City of Richmond
Urban Development Division

Report to Development Permit Panel

To: Development Permit Panel
From: Joe Erceg
Manager, Development Applications
Re: **Application by MB 628 Ventures Ltd. for a Development Permit at
8580 Cambie Road**

To DPP - Mar 26, 2003
Date: February 24, 2003
File: DP 97-121069

DRAWING TITLE: SITE PLAN
1

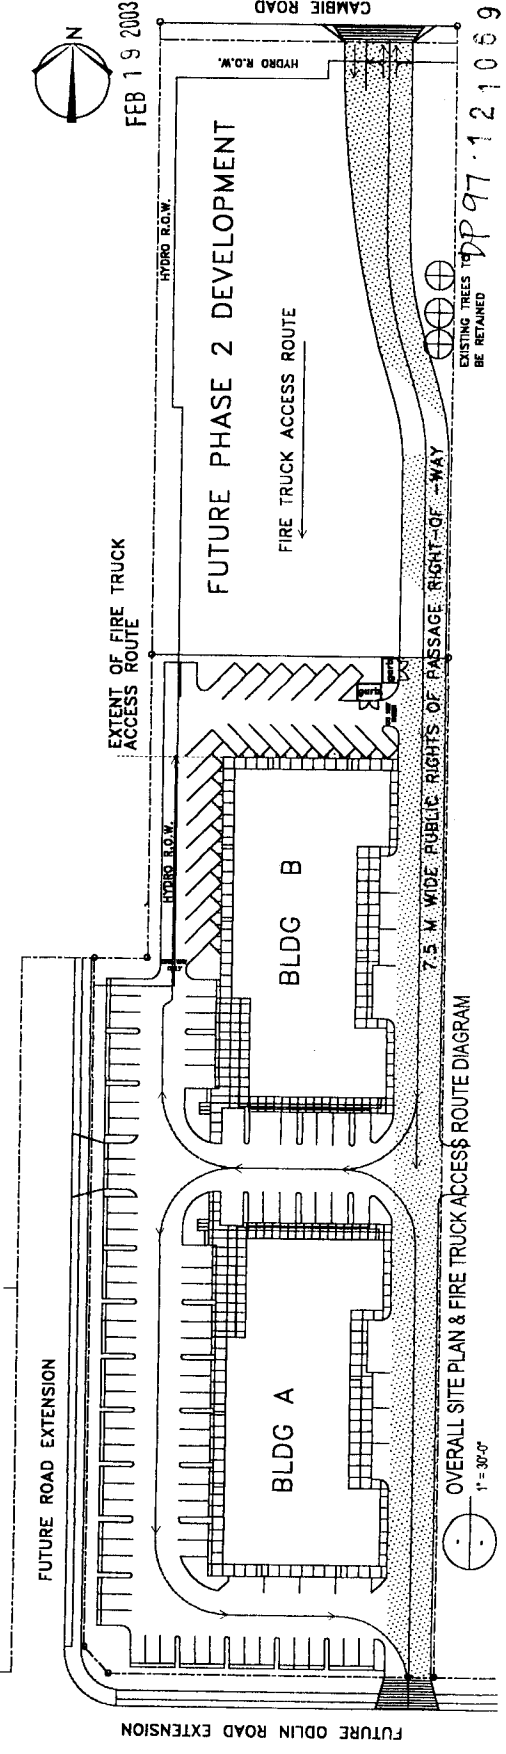
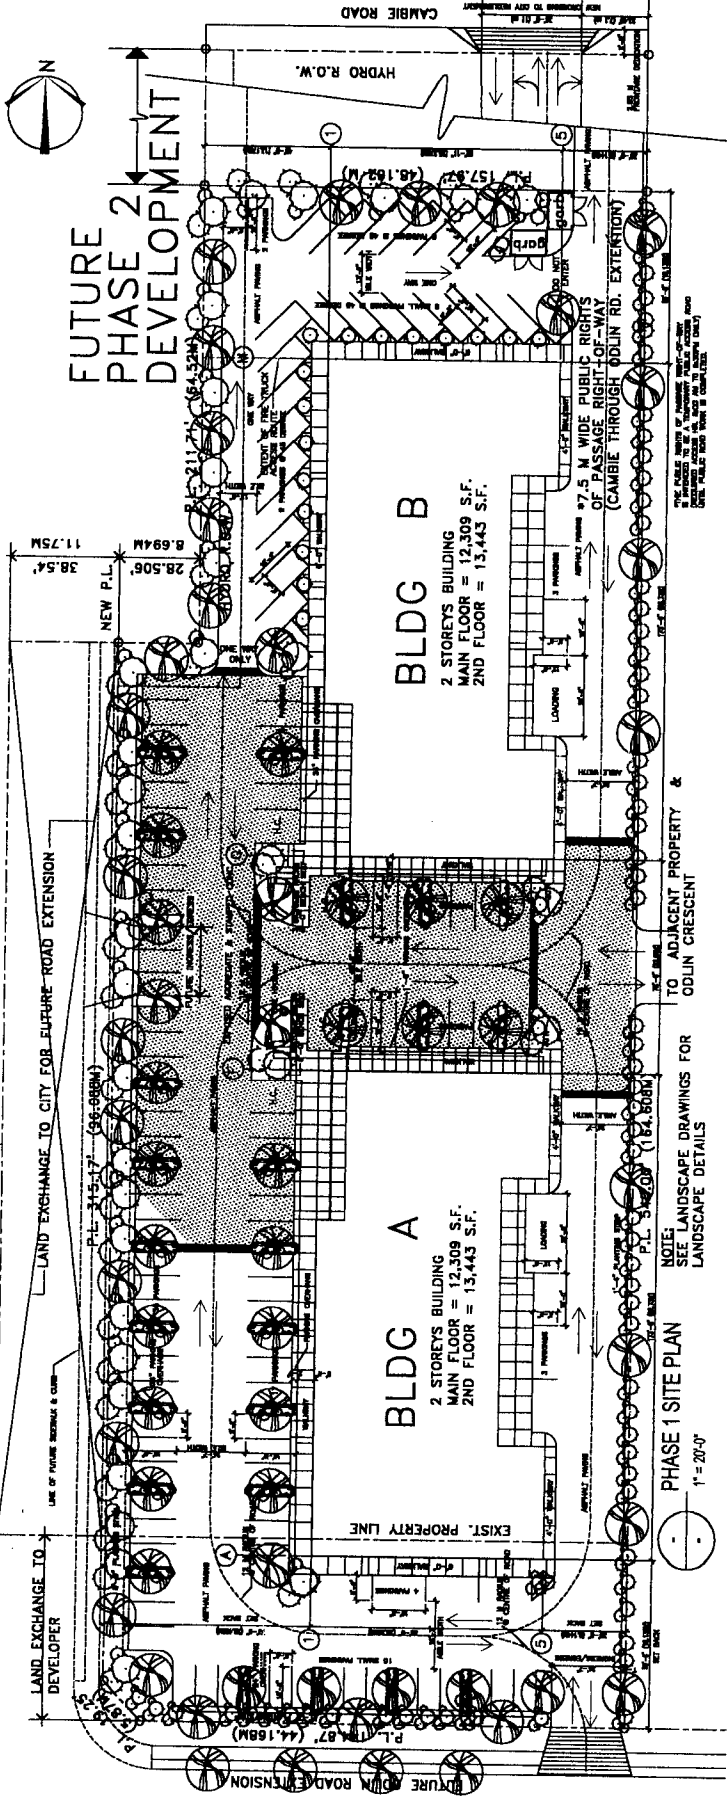
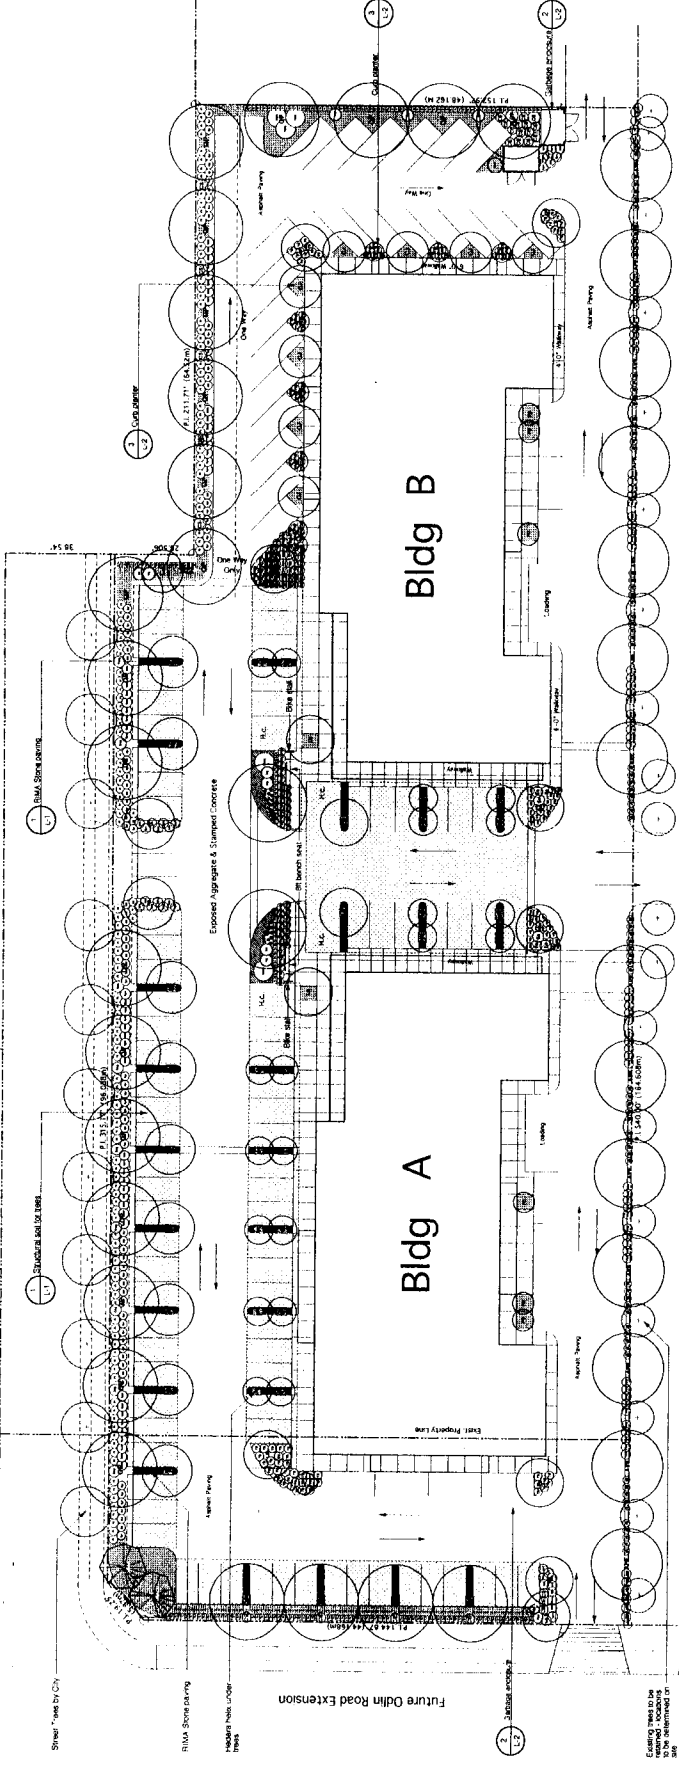
Ensure access routes meet all requirements. Pavers for access surface must be solid. Access must be a minimum 7.3 m in width with a turning radius of 12 m centre-line. Provide water flow calculations. Indicate hydrant locations. Provide fire safety plan for construction and occupancy phases. Ensure that trees and landscape, as well as parked vehicles do not encroach on access. Ensure that overhead clearance is minimum 5 m. Provide details of mechanical and electrical systems including fire alarm and sprinkler systems.

The applicants have submitted a plan of access routes, and has resolved to attend to other fire safety matters at the Building Permit stage.

DRAWING TITLE
Landscape Plan
#2

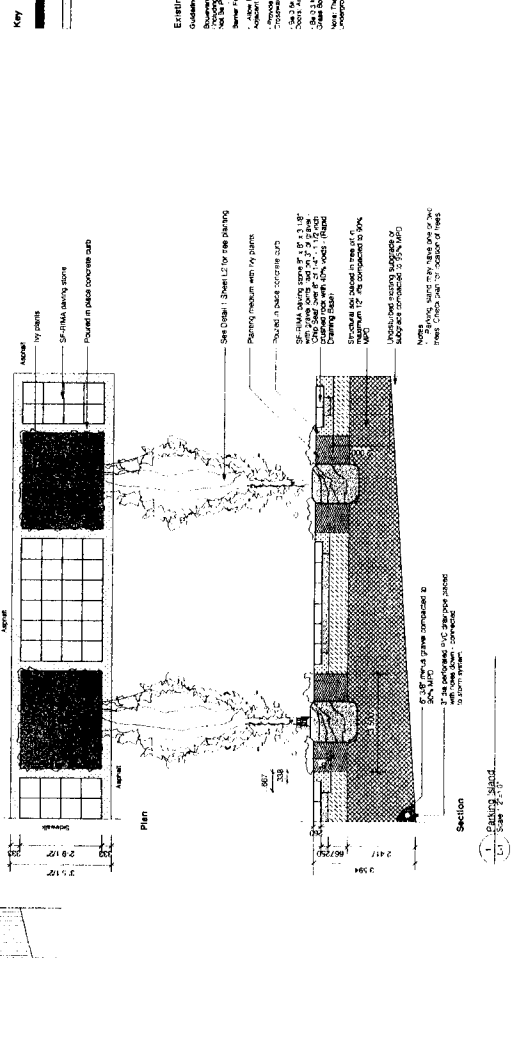
Provide a survey of existing trees and add replacement trees to the landscape plan. See also the Analysis of the City Centre Guidelines. *The applicants have provided a survey of existing trees on the site, of which there are nine (9) in this phase, mainly fruit trees and smaller deciduous trees. The landscape plan indicates all of these trees being removed and replaced with 10 cm caliper trees.*
